**Product modification of the UK 10.3-HESI and UK 10.3-CC HESI fuse terminal blocks  
Please forward this information to your electrotechnical departments!**

The fuse terminal blocks of the UK 10.3-HESI and UK 10.3-CC HESI series have comprehensively been optimized. The substantial changes are explained on the basis of the pictures enclosed (see below).

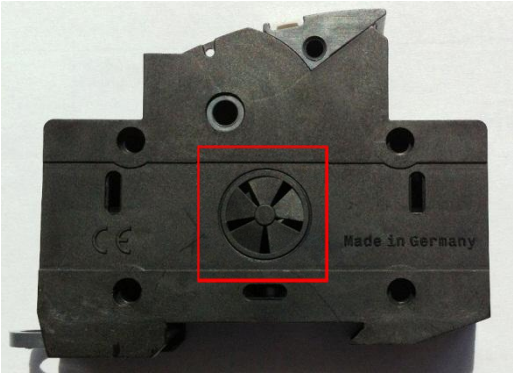
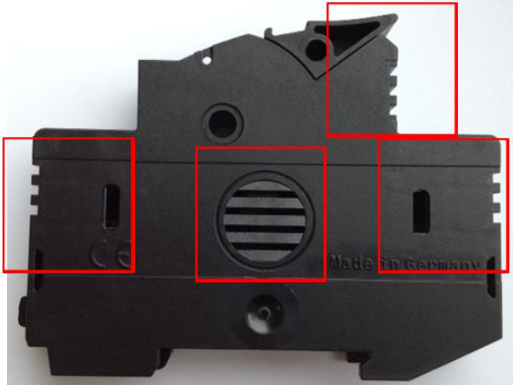
Previous production status	New production status
Improved cooling through changed and additional vents

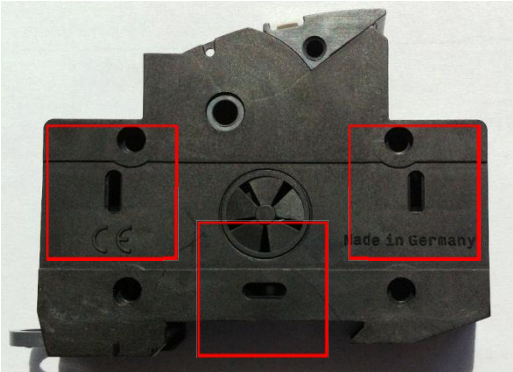
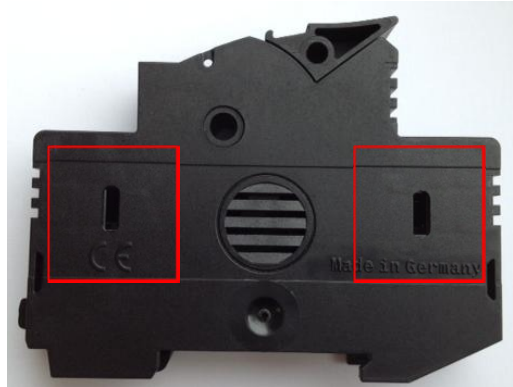
Only two instead of three recesses for the mechanical connection/blocking of terminal blocks

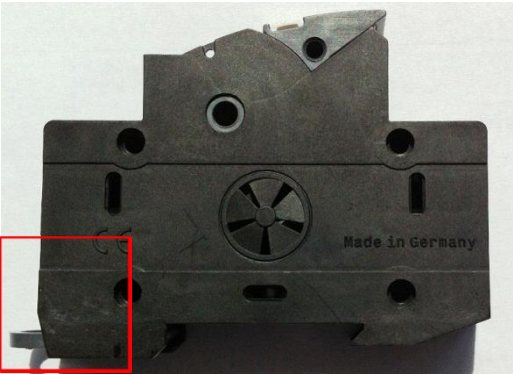
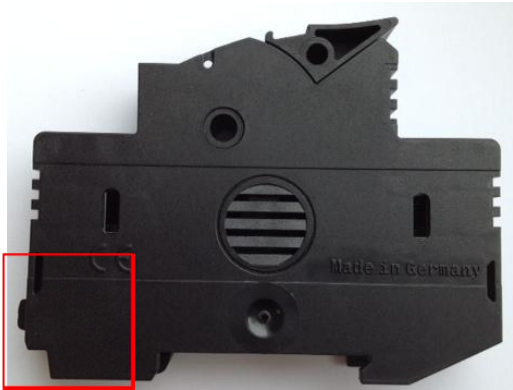
Improved snap-on mechanism for the removal of the terminal block from the DIN rail

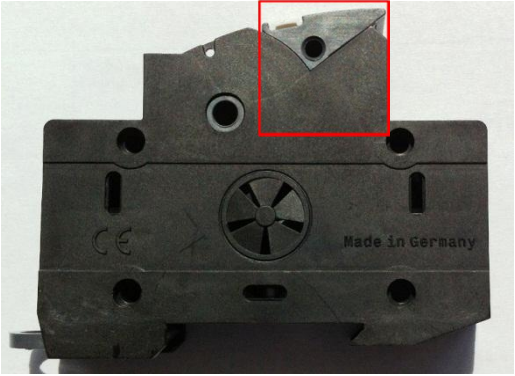
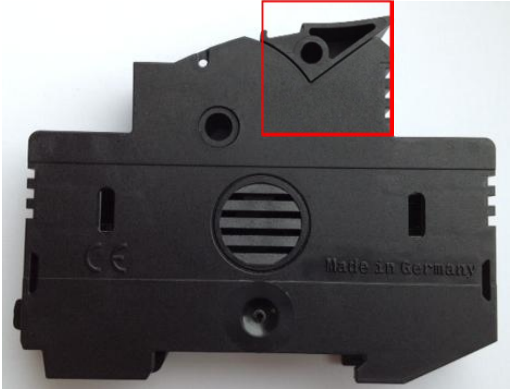
Previous production status	New production status
Newly designed fuse swing lever mechanism. Black color instead of grey

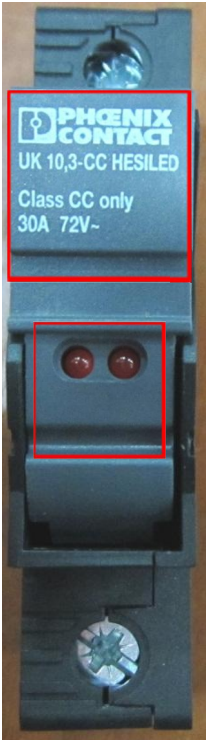
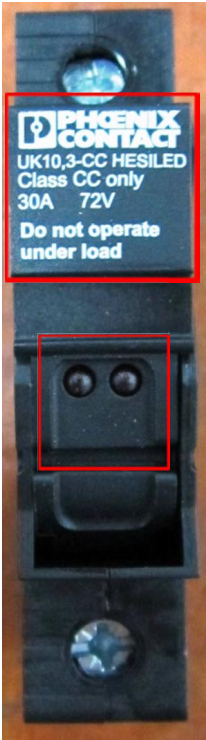
Inscription with additional warning. As regards types with light indicators, now LEDs gleam black when they are not driven (previously red)
